Paramount Theater
139 N COUNTY RD
PALM BEACH, FL 33480

12/07/23
FINAL
DROP-OFF

C-101

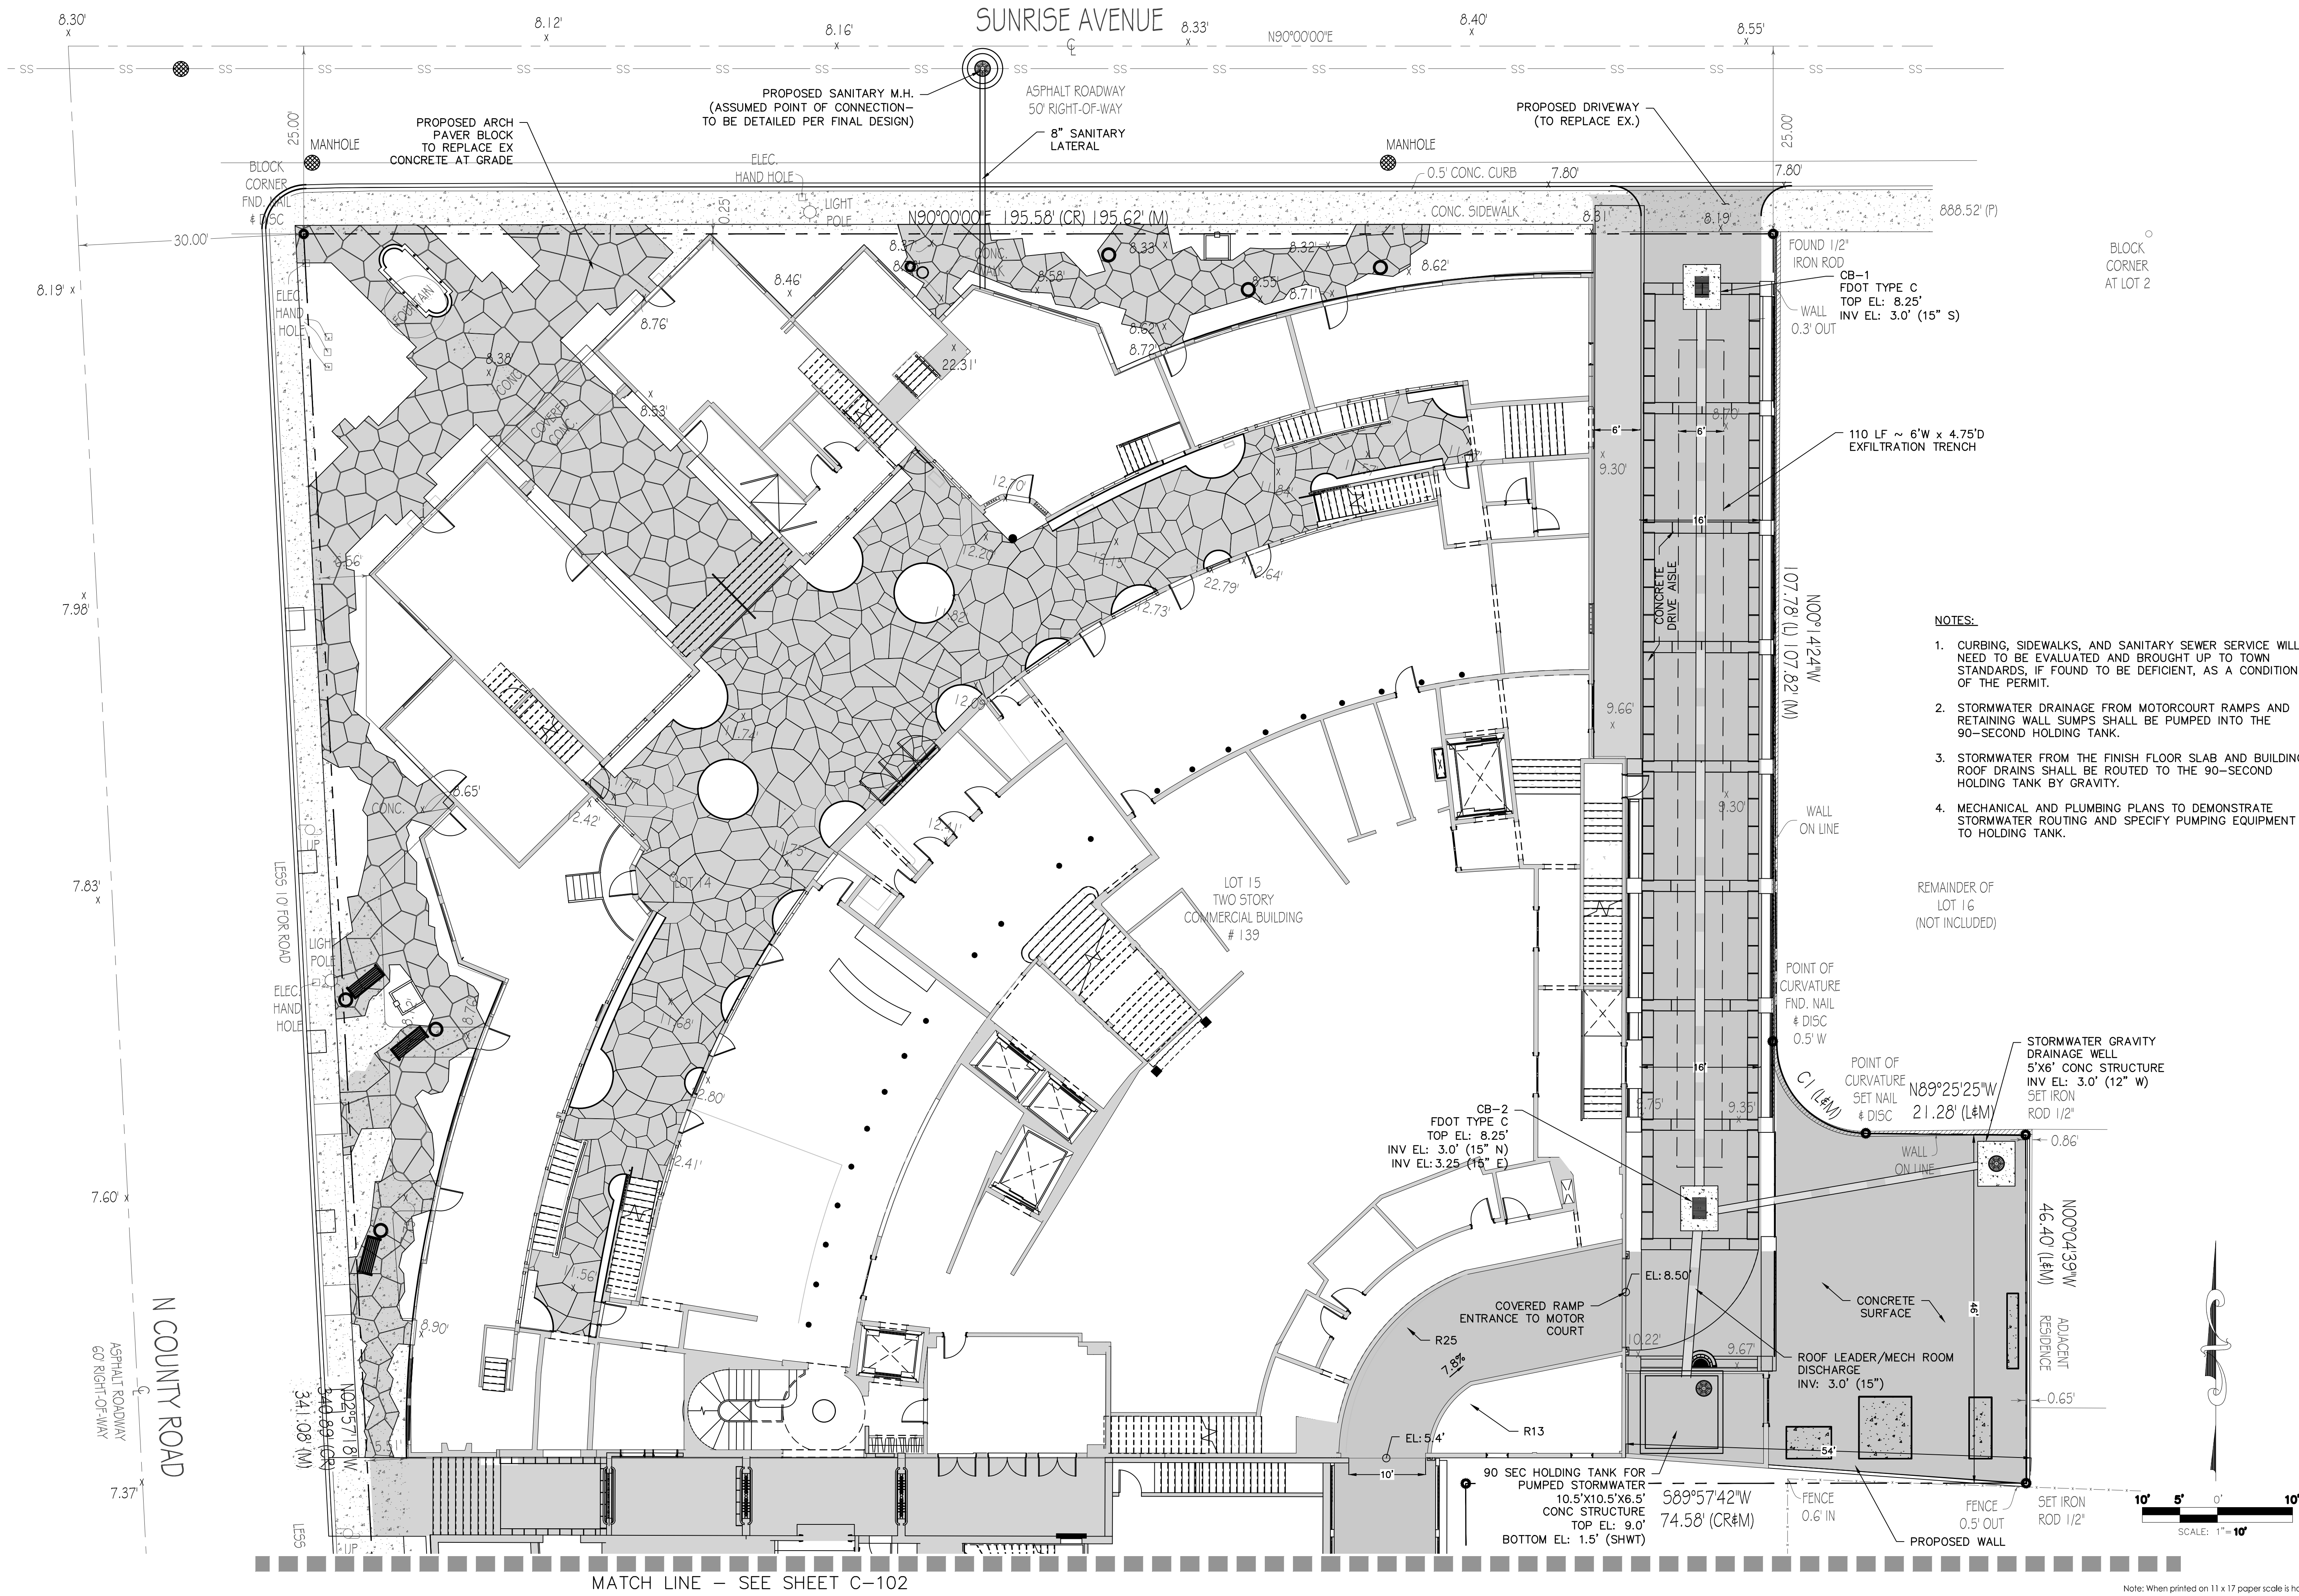
- NOTES:
1. CURBING, SIDEWALKS, AND SANITARY SEWER SERVICE WILL NEED TO BE EVALUATED AND BROUGHT UP TO TOWN STANDARDS, IF FOUND TO BE DEFICIENT, AS A CONDITION OF THE PERMIT.
 2. STORMWATER DRAINAGE FROM MOTORCOURT RAMPS AND RETAINING WALL SUMPS SHALL BE PUMPED INTO THE 90-SECOND HOLDING TANK.
 3. STORMWATER FROM THE FINISH FLOOR SLAB AND BUILDING ROOF DRAINS SHALL BE ROUTED TO THE 90-SECOND HOLDING TANK BY GRAVITY.
 4. MECHANICAL AND PLUMBING PLANS TO DEMONSTRATE STORMWATER ROUTING AND SPECIFY PUMPING EQUIPMENT TO HOLDING TANK.
